Request to amend construction management plan

Property description	Lot 122 SP284713
Property location	122 Marine Parade, MIAMI QLD 4220
DA reference	MIN/2025/655

Development: Nalu

SITE ESTABLISHMENT - GROUND FLOOR

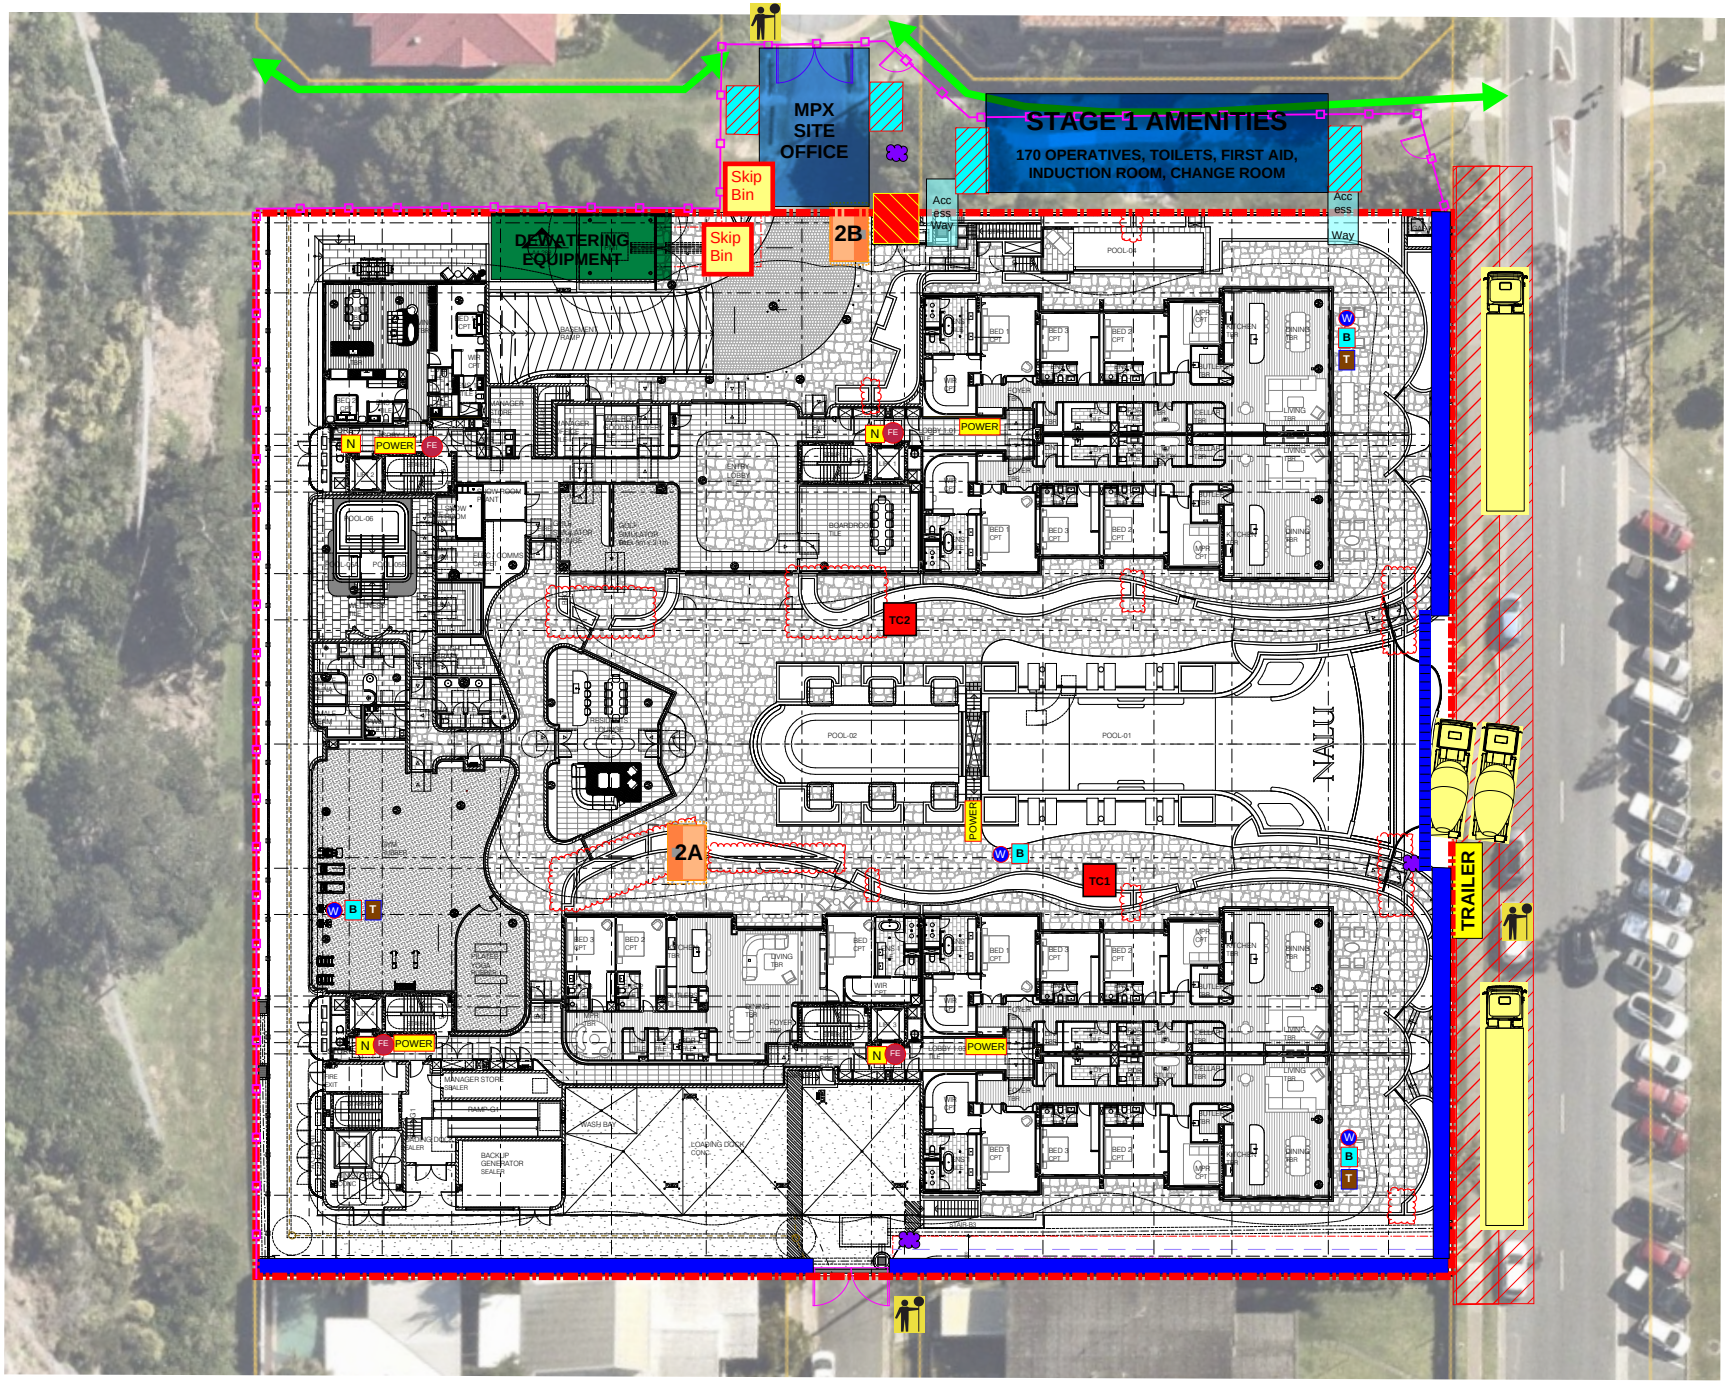
The applicant must advise where general waste and skip bins will be located on site and provide details of the collection and control of workers and building waste. **Multiplex Response:** Please refer to the attached drawing which shows on Plan view the intended placement of our skip bins for the project. Rubbish will be removed from site by a licensed waste contractor and taken to a transfer facility for separation. Waste material from the structure activities will be lowered by tower cranes in skip bins, whereas finishes trades will utilise both hoists to remove waste material to designated locations in the basement and on ground level. These bins will be emptied daily into a skip bin. Periodical bin collections will be required for the removal of the construction waste.
